# Temporary Dewatering Design

Durham Meadows Waterline Remedial Design  
Durham, Middlefield, and Middletown, Connecticut

## GOVERNMENT COMMENTS:

Re: Geotechnical Engineering Design Services – Revision 1  
Durham Meadows Waterline Remedial Design  
Durham, Middlefield, and Middletown, Connecticut  
Terracon Project No. J2195015

**DEWATERING DETAILS**

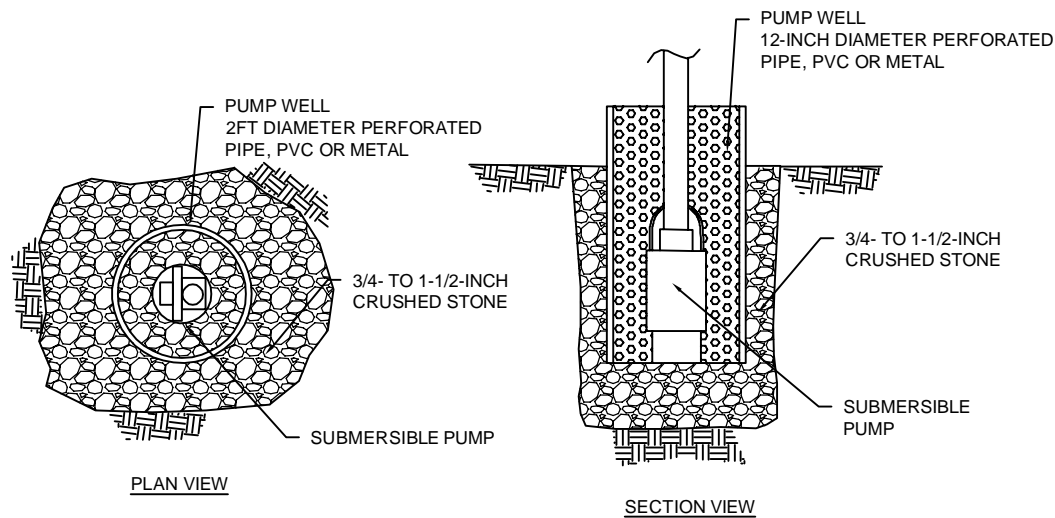
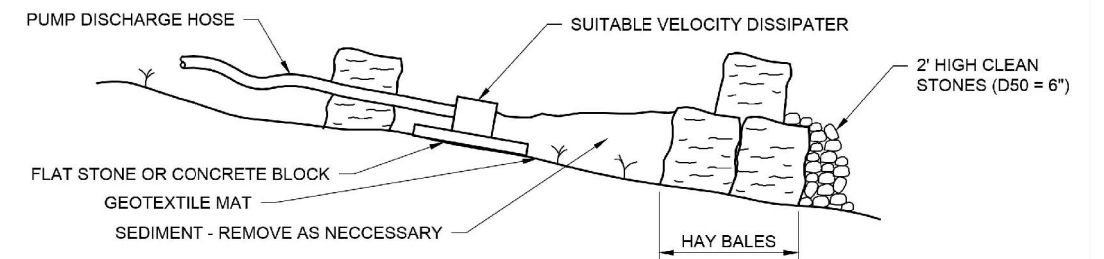
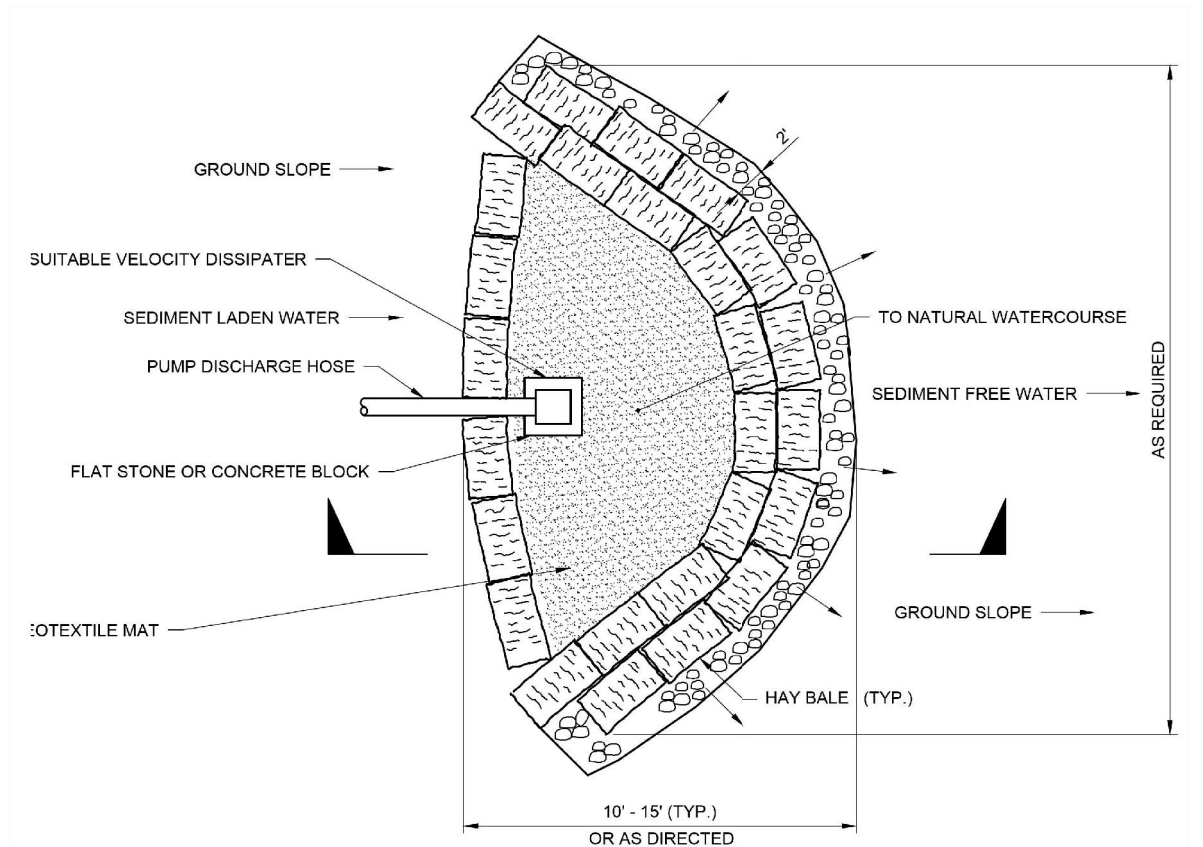
Could not locate the following comments on the drawing. Suggest you add under comments under General Notes.

1. The CT DEEP General permit will apply to all dewatering activities. Registration is not necessary for the work on this project. All dewatering activities will be done in compliance with the laws, regulations, and codes of the CT DEEP General Permit.
2. All Crossings will be have a separate submittal addressing dewatering activities.
